CITY PLAN COMMISSION**THURSDAY, AUGUST 6, 2026****FILE NUMBER:** PLAT-26-000179**SENIOR PLANNER:** Sharmila Shrestha**LOCATION:** Plano Road, north of Lyndon B. Johnson Freeway/ Interstate Highway No. 635**DATE FILED:** July 10, 2026**ZONING:** IR**CITY COUNCIL DISTRICT:** 10**SIZE OF REQUEST:** 6.627-acres**APPLICANT/OWNER:** 10200 Plano Road, LLC

REQUEST: An application to replat a 6.627-acre tract of land containing part of Lot 1 in City Block C/8052 and City Block 8052 to create one 1.254-acre lot and one 5.373-acre lot on property located on Plano Road, north of Lyndon B. Johnson Freeway/ Interstate Highway No. 635.

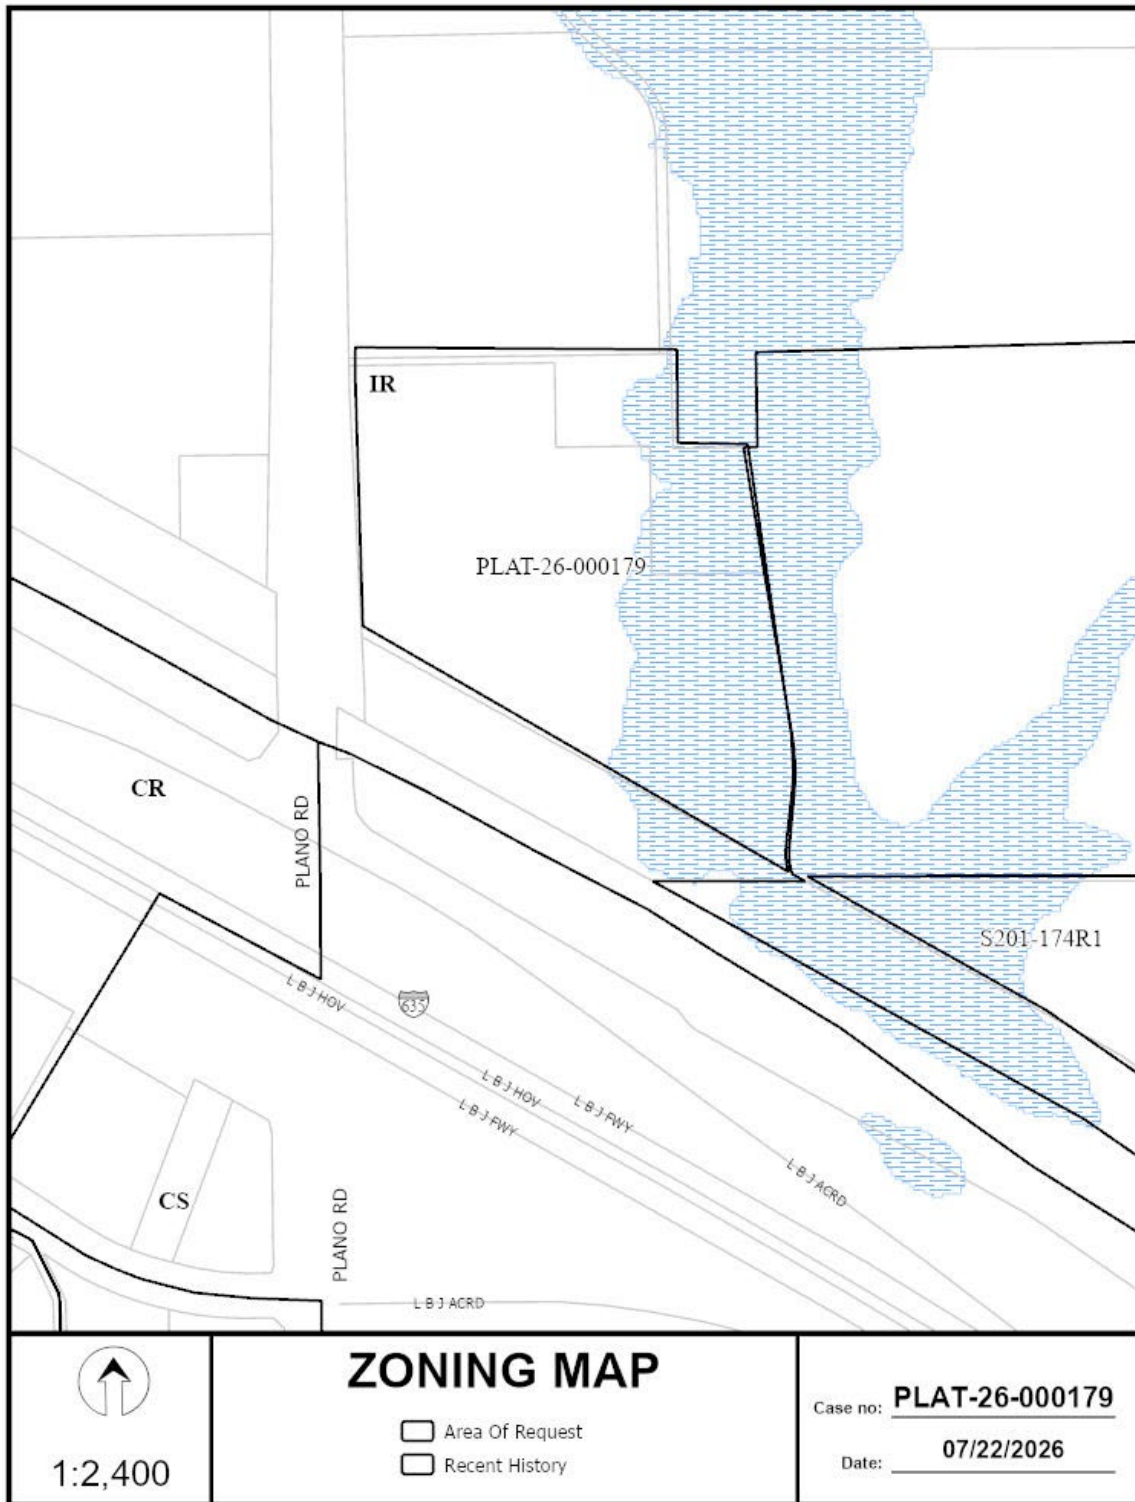
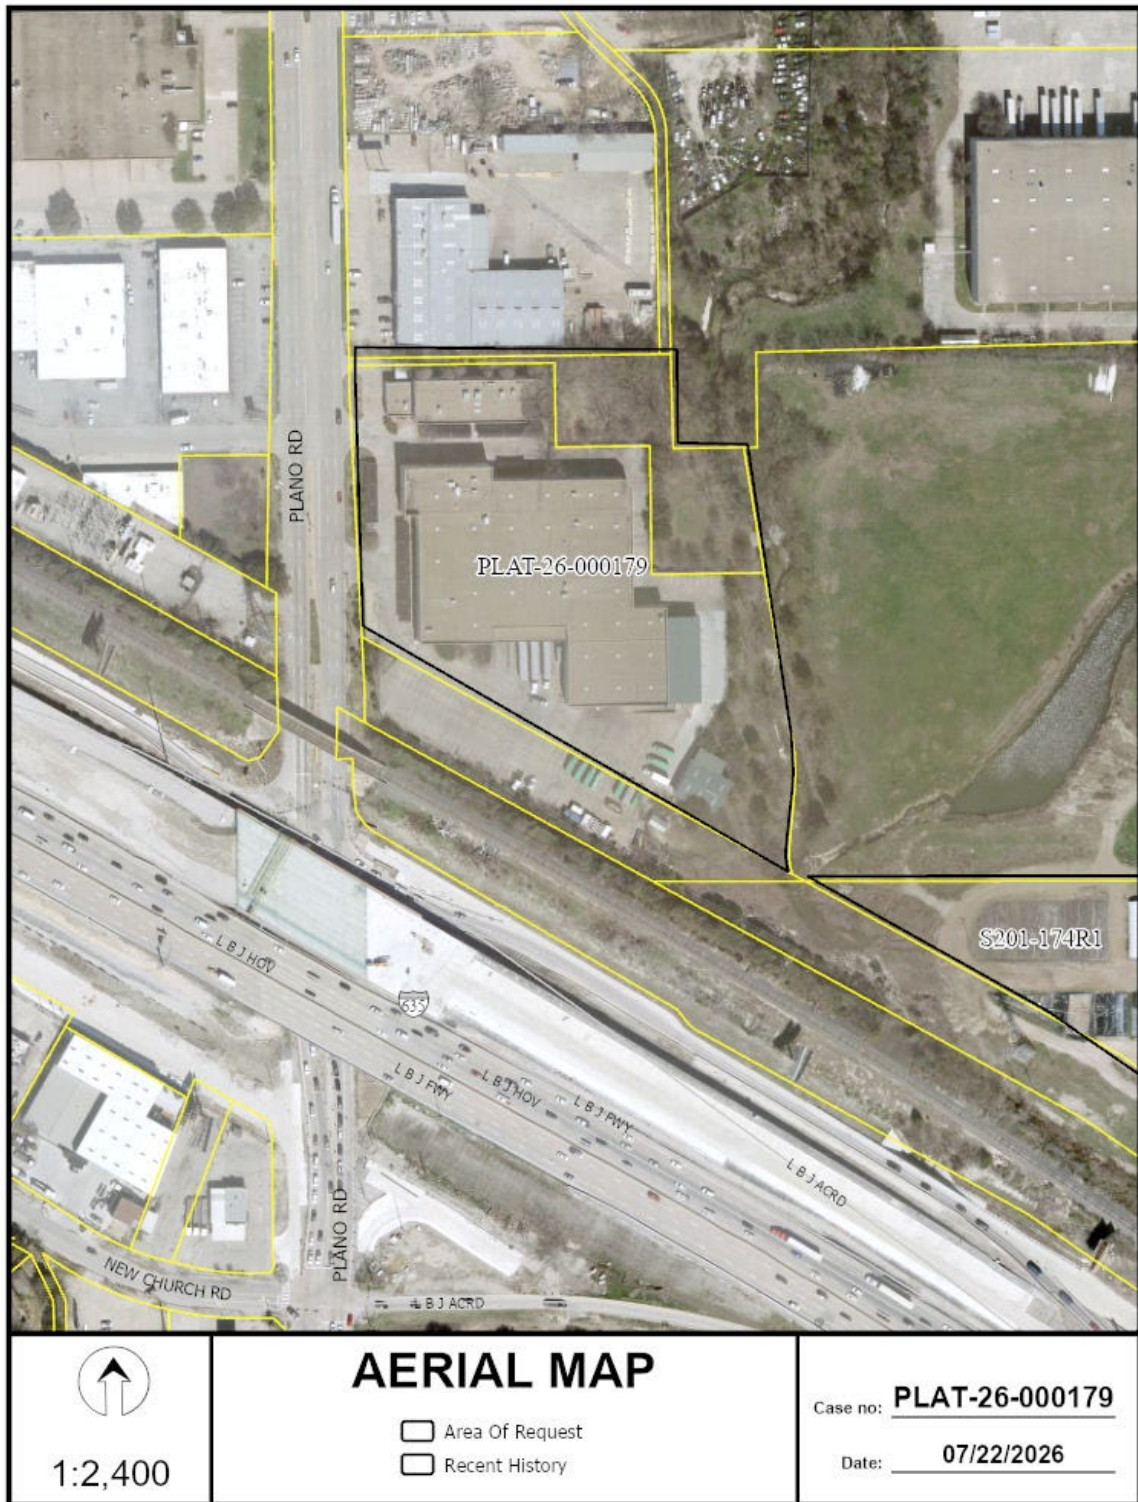
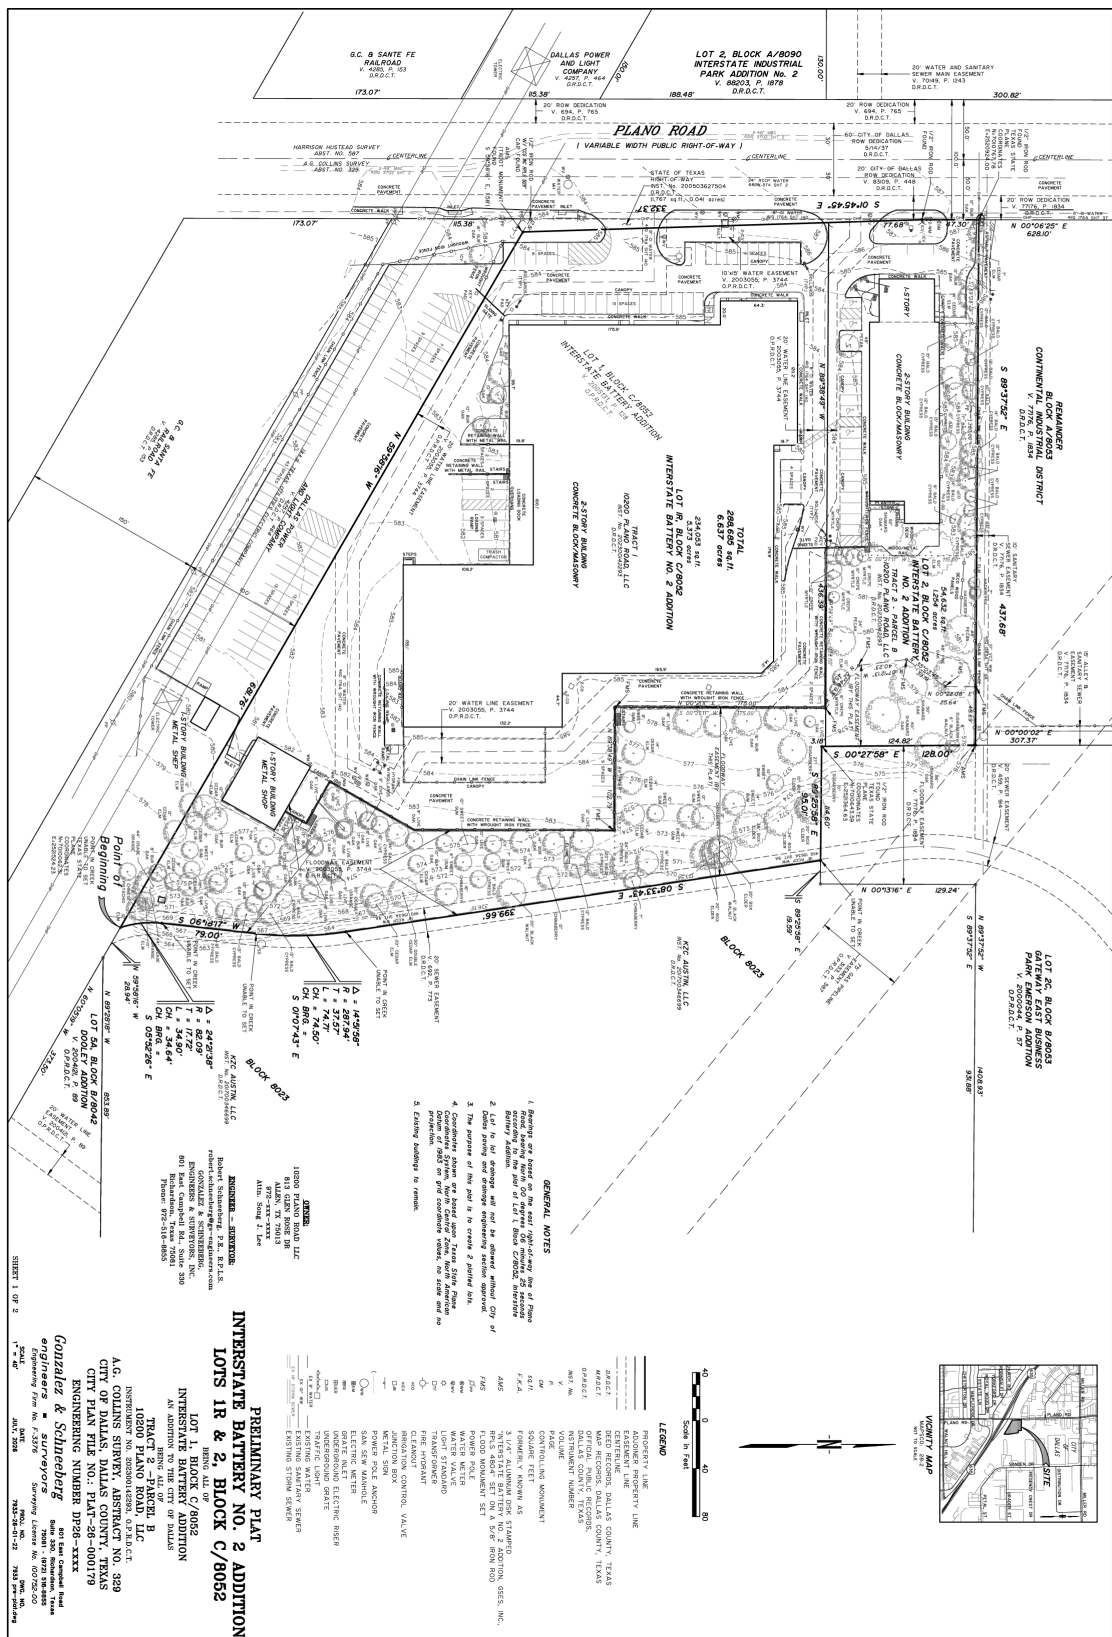
STAFF RECOMMENDATION: The request complies with the requirements of the IR Industrial/Research District; therefore, staff recommend approval of the request subject to compliance with the following conditions:

5. Any new or existing structure may not extend across new property lines. *Section 51A-8.503(e)*
6. On the final plat, all easement abandonments, and ROW abandonments must be by separate instrument with the recording information shown on the face of the plat. A release from the Real Estate Division is required prior to the plat being submitted to the Chairman for signature.

7. On the final plat, include two boundary corners tagged with these coordinates: "Texas State Plane Coordinate System, North Central Zone, North American Datum of 1983 on Grid Coordinate values, No Scale and no Projection."

9. Provide ALL supporting documentation (i.e. deeds, plats, ordinances, easements...etc) with a completed Final Plat Checklist to the Survey Plat Review Group (**SPRG**) with the Final Plat Submittal **after** City Plan Commission Approval.
10. Prior to the final plat, submit a tree survey to the Arborist. A release from the arborist is required prior to an early release request or the recordation of the plat, whichever occurs first.
11. The number of lots permitted by this plat is 2.

15. On the final plat, determine the 100-year water surface elevation across this addition.
16. On the final plat, dedicate floodway easement, floodway management area or floodway easement (within common area), with the appropriate easement statement included on the face of the Plat. 51A 8.611(d); DWU Floodplain Management; Drainage Design Manual Addendum V

18. On the final plat, specify minimum fill and minimum finished floor elevations. *Section 51A-8.611(d), Trinity Watershed Management.*
19. On the final plat, show the natural channel set back from the crest of the natural channel. *Section 51A-8.611(d), Trinity Watershed Management.*

22. Prior to final plat, submit a completed final plat checklist and all supporting documents.
23. Show recording information on all existing easements within 150 feet of property.

24. Additional design information is required for assessment. Site plan must be submitted showing proposed development, building finished floor elevation, development, existing mains – including downstream manhole, and proposed water and wastewater service locations. Submit water/wastewater engineering plans to 320 E. Jefferson Blvd., Room 200, Attention: Water and Wastewater Engineering.
25. Water and wastewater main improvement may be required by Private Development Contract. Submit water/wastewater engineering plans to 320 E. Jefferson Blvd., Room 200, Attention: Water and Wastewater Engineering.
26. Existing and any proposed Water and Wastewater Easements must be shown and/or increased to conform to current design standards. Notice: Minimum DWU easement size 20' for one utility and 25' for both water and sewer. Larger diameter or deeper mains may require additional width.

27. Plans must comply with City's street lighting standards. See illumination standards in Street Design Manual.
28. On the final plat, add "Lyndon B. Johnson Freeway/ Interstate Highway No. 635."
29. On the final plat, identify the property as Lots 1A and 2A (north lot) in City Block C/8052.
